# Navigation Stakeholder Engagement Report

NY/NJ Harbor and Tributaries Study

August 25 2022 | 12635.106.R2.RevB

## 5. Summary of Stakeholder Comments

Figure 5.1: Sandy Hook SSB Adjustment Recommended by Participants

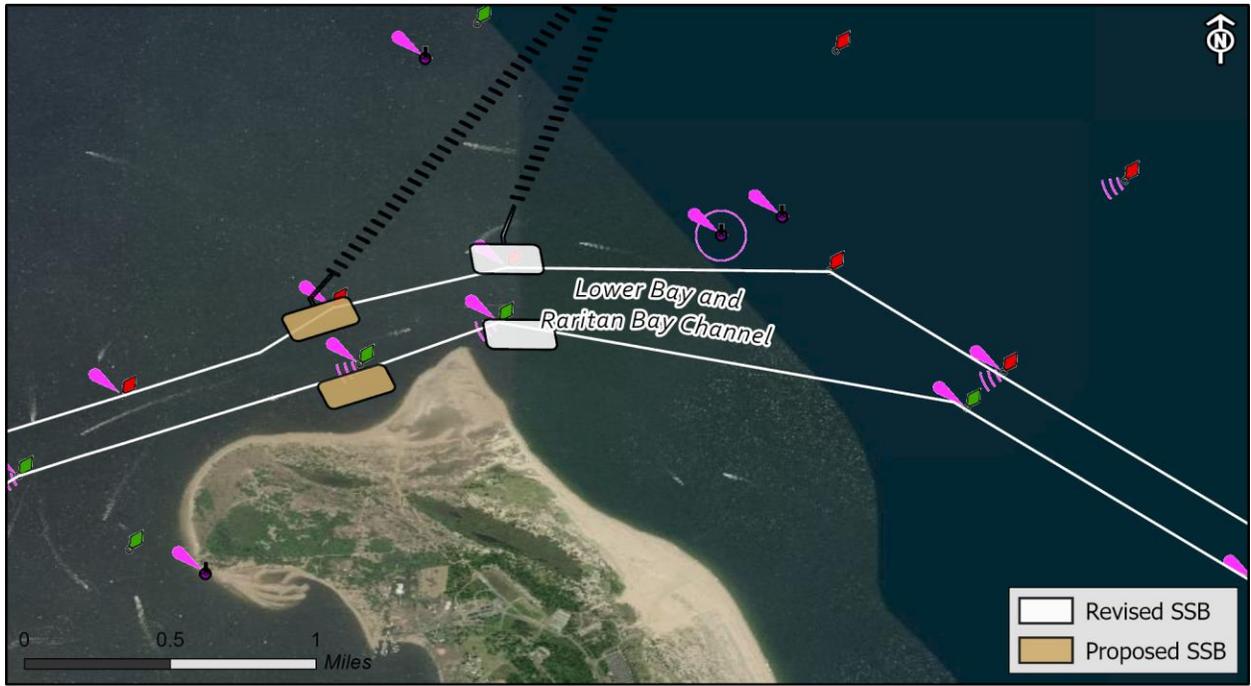
- Stakeholders recommended that the location of the Sandy Hook SSB be moved east towards the 2-2A buoys for the following reasons:
  - The area just off the point is subject to consistent shoaling, and it was suggested that the SSB may be oriented to limit this shoaling.

- The present position of the Sandy Hook gate will be in direct view of inbound tankers lining up for the west Sandy Hook approach, thus impairing their view.

- Currents at the existing location can be opposing either side of the gate.
  - See Figure 5.1 below for adjustments recommended by the participants.
